# LVD SCSI Driver Proposal

Richard S. Moore  
Adaptec

# Points of Interest

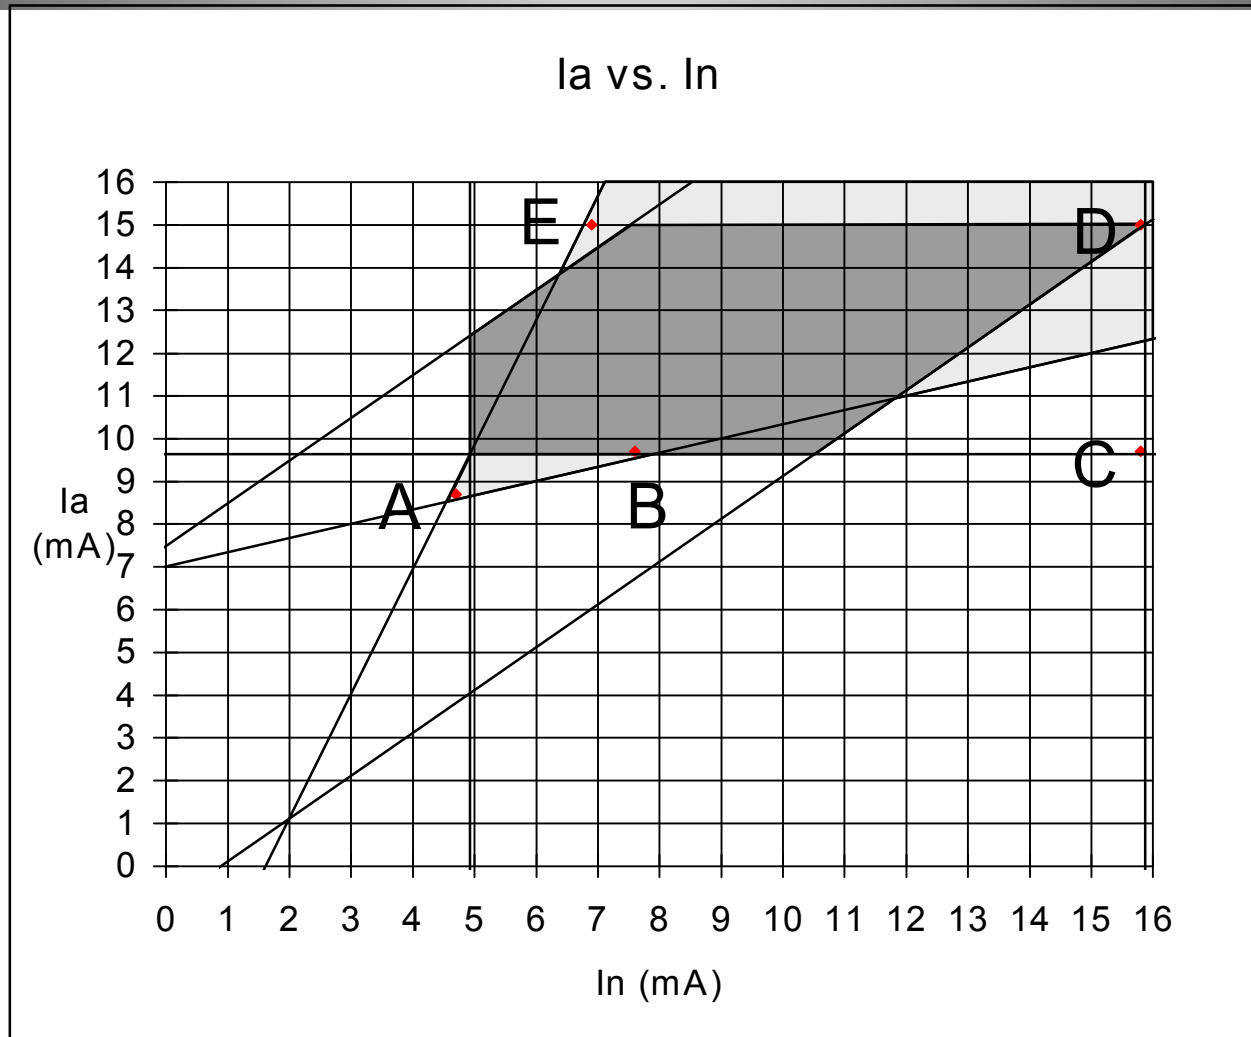
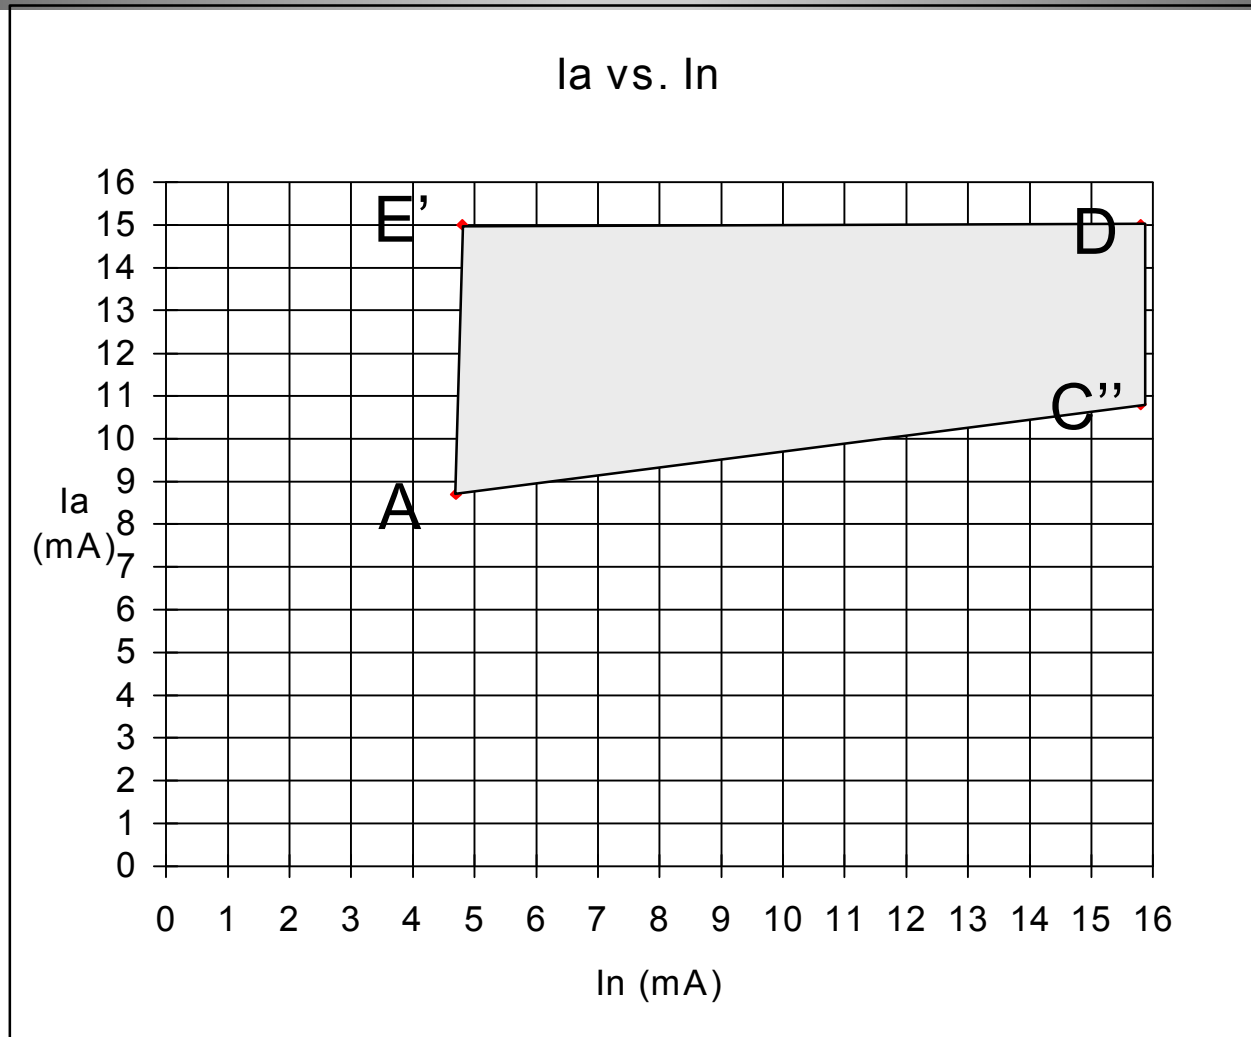
- Consider region ABCDE.
- Point C fails in Kevin Gingerich's spreadsheet model. Either move up or move left.
- Points B and E are unnecessarily strict. Eliminate B and move E to the left.

- Consider AC'DE'. Boundary includes 3 diagonals and one horizontal segment.
- AC''DE' requires one less diagonal segment and is therefore easier to specify.
- The spreadsheet model shows that all four corners of AC'DE' or AC''DE' give sufficient assertion-to-negation and negation-to-assertion transitions under worst case conditions.

# Objection: 4:1 Voltage Ratio

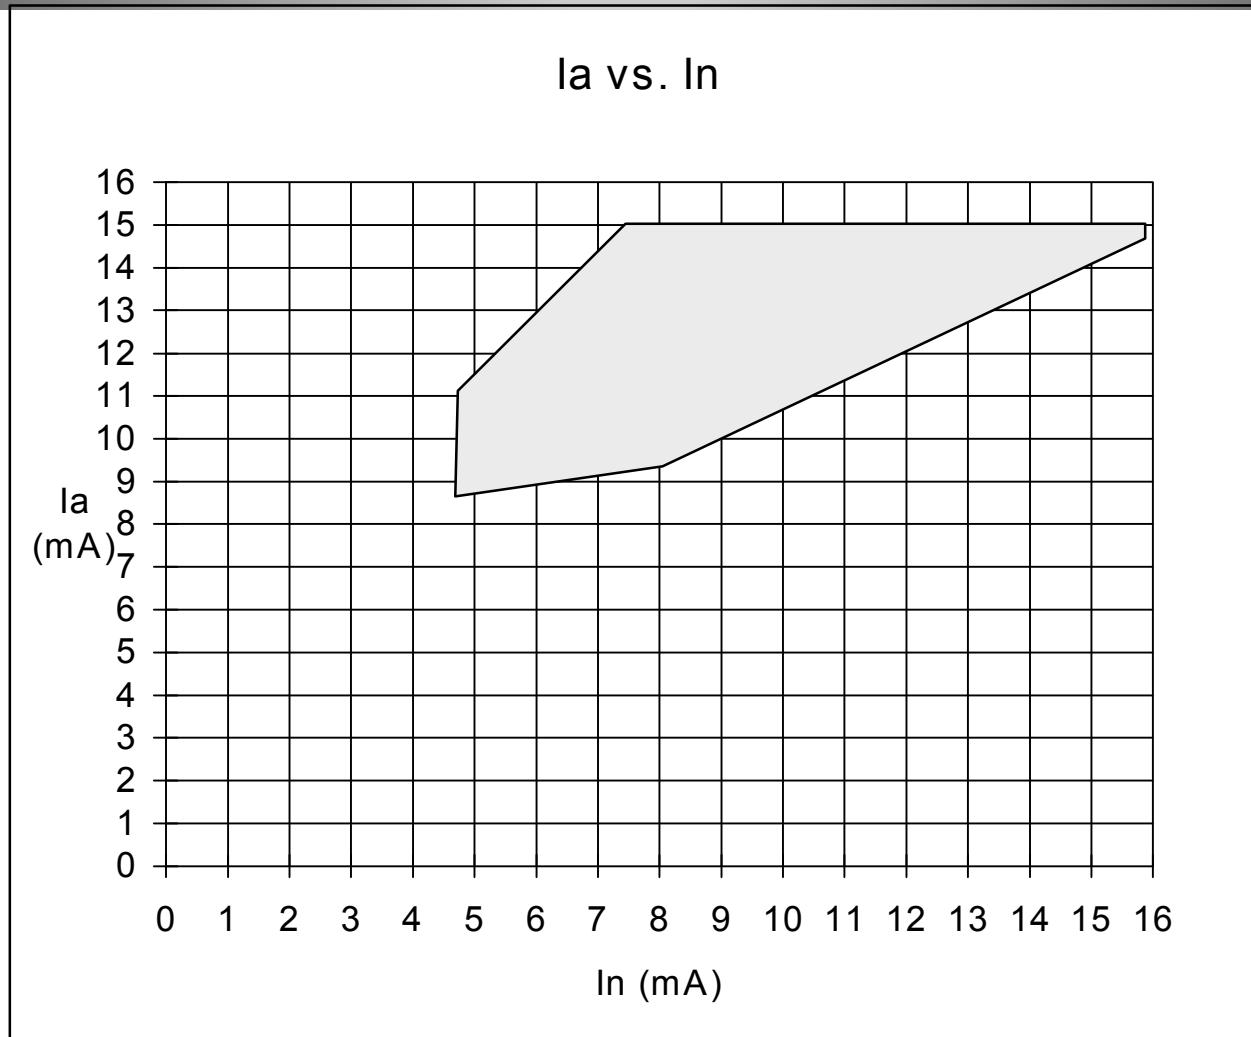
- Need to meet receiver input balance requirements.
- Derive an additional boundary condition:

$$|V_N| \leq 4|V_+|$$

$$-V_N \leq 4(V_N + (I_A + I_N)Z_L/2)$$

$$5V_N + 2(I_A + I_N)Z_L \geq 0$$

$$5(I_N R_T/2 + V_B) \leq 2(I_A + I_N)Z_L$$

$$I_A \geq 3.8 \text{ mA} + .69I_N$$

- Similar derivation to ensure  $|V_A| \leq 4|V_-|$  gives:

$$I_N \geq -2.9 \text{ mA} + .69I_A$$

$$I_A \leq 4.2 \text{ mA} + 1.45I_N$$
